The Sizewell C Project

9.73 Comments at Deadline 7 on Submissions from Earlier Deadlines and Subsequent Written Submissions to ISH1-ISH6 - Appendices

APPENDIX J: LANDSCAPING AND NOISE LETTERS TO FERN, MOLLETTS FARM AND MR & MRS LACEY

SIZEWELL LINK ROAD PROPOSED LANDSCAPE MASTERPLAN AND FINISHED LEVELS FORDLEY ROAD

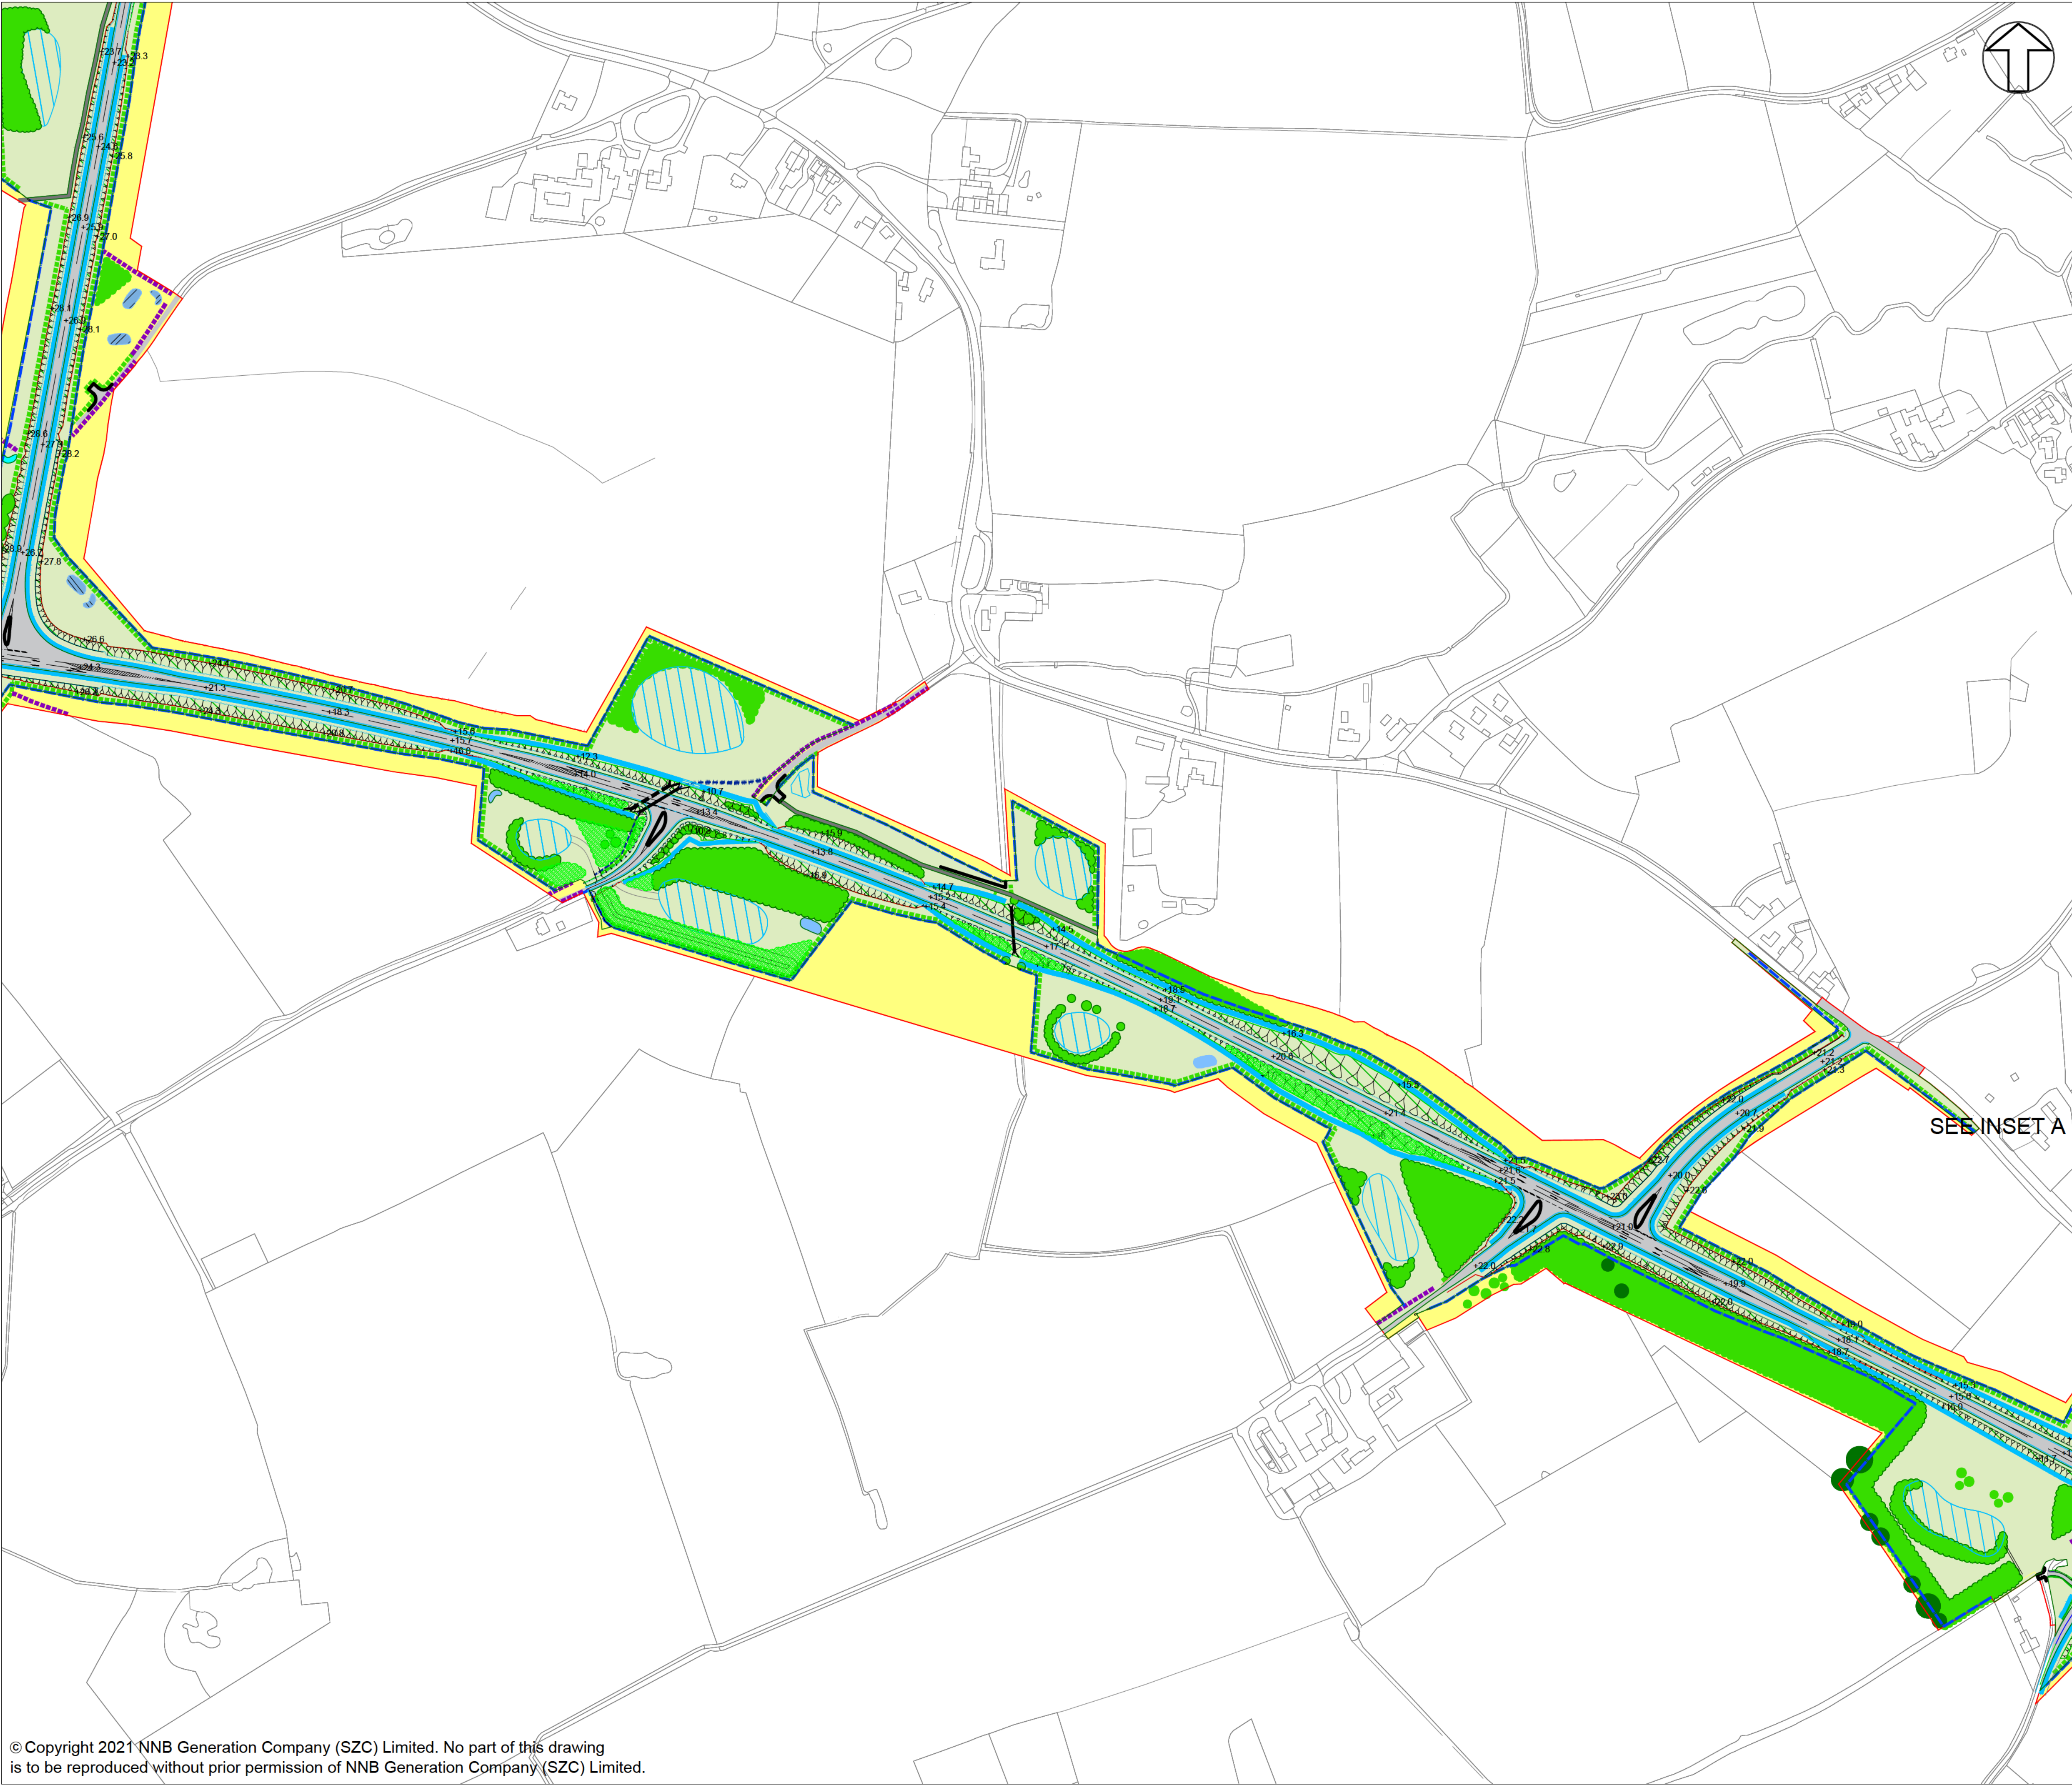
The revised landscape proposals, for further discussion, indicate a proposed 2m high bund along the southern edge of the closest proposed attenuation basin, with a 15m wide belt of woodland planting on top of it to soften views towards the proposed link road. The plan also indicates a stretch of close board fencing adjacent to your property boundary to provide additional screening while the planting establishes. The plan also indicates further planting to the northwest of the Fordley Road junction within the western attenuation basin area, as well as further areas on the slopes where the proposed road would be on embankment. Discussions are ongoing with the ecology team to develop an appropriate planting mix for the proposals. This will be presented to you at the next meeting along with the sizes of planting.

In addition, the highway engineers are currently reviewing the size and position of both of the attenuation basins closest to your property to see any additional space for further planting could be created. Further updates will be provided at the next meeting.
